Well, Councilman Livingston has posted several items on social media from BJCJSTP Staff that are misrepresentations and included an editorial that are potentially slanderous. The items are addressed in the list below:

Adam Afify is at Binghamton Johnson City Waste Water Treatment *** Plant.

1. Headworks leaking wall Picture #1, with electrical panels. -

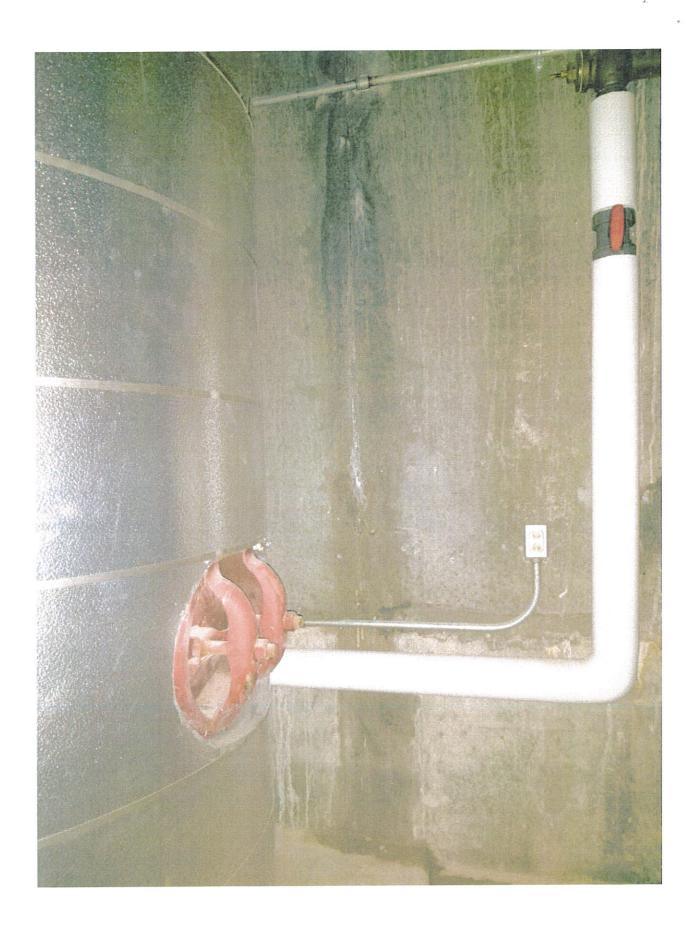
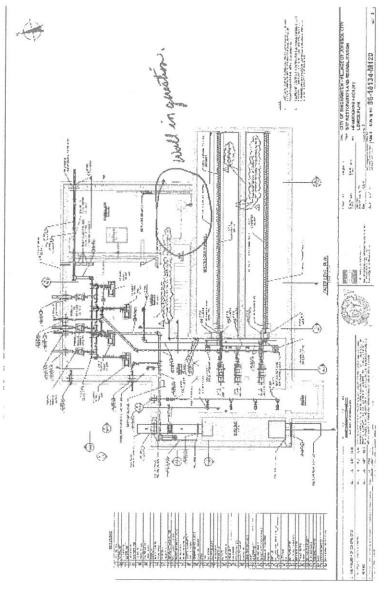
<u>Alleged Condition – STP Staff alleges that the wall is leaking and is shoddy construction.</u>

<u>Alleged Condition -</u> STP Staff also suggest that the control panels are covered in residue, and implying that they could be damaged.

<u>Actual Condition</u> - This photo appears to be several weeks old. The headworks was put into service June 26 It does not show the completed work, and does not show that the leak has been addressed. The wall that the panels are located on backs up to the north grit channel. See attached drawing. The leak test on the channel was passed in January, 2019. All visible leaks were sealed at that time. At the time of the photograph, there are no visible leaks, just past leaks that were appropriately sealed during construction.

<u>Actual Condition –</u> The issue is cosmetic, and it was addressed on the day that the picture was provided. These panels are not damaged. The streaky appearance is from water from the core drill process above the panels which ran down the wall. These panels have already been cleaned

up, and were not damaged in any way. The panels were inspected after the drilling process, and it was confirmed that the panels did not have any intrusion of water into the panels. Furthermore, the manufacturer certified the installation of the panels prior to putting the Headworks on line on June 26, 2019, and they confirmed that there were no warranty concerns.

2. Headworks leaking wall Picture #2 with Insulated Hot Water Pipe. -

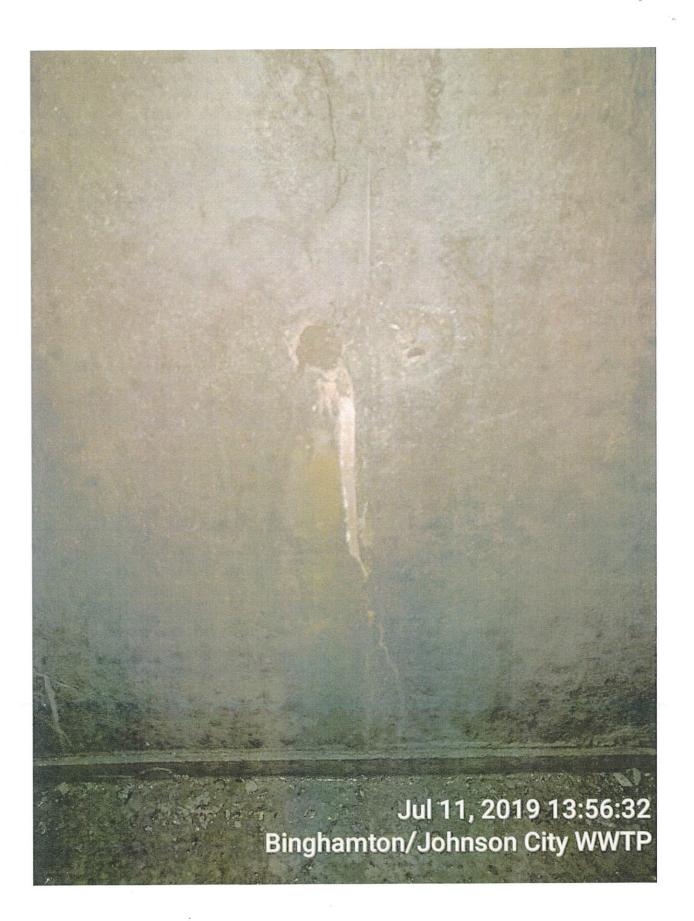
<u>Alleged Condition –</u> The text indicates that the wall is leaking and is an example of shoddy concrete work.

<u>Actual Condition –</u> This wall picture is directly adjacent to the picture in item 1. It is not more than a few feet away from the picture above. See attached photo. As we have said before, it is not uncommon for concrete to leak water after it has been cast. That is the reason that we specify that a leak test be performed for all water holding structures, and for all visible leaks to be fixed on concrete structures. There are standard commonly accepted industry practices for sealing leaks in concrete. A person knowledgeable of the industry would know about these industry accepted leak sealing products. As stated above, any leaks in the wall were sealed several weeks or even months ago. The leak in the wall could not be discovered until the leak test of the grit channel. The leak test was passed in early winter.
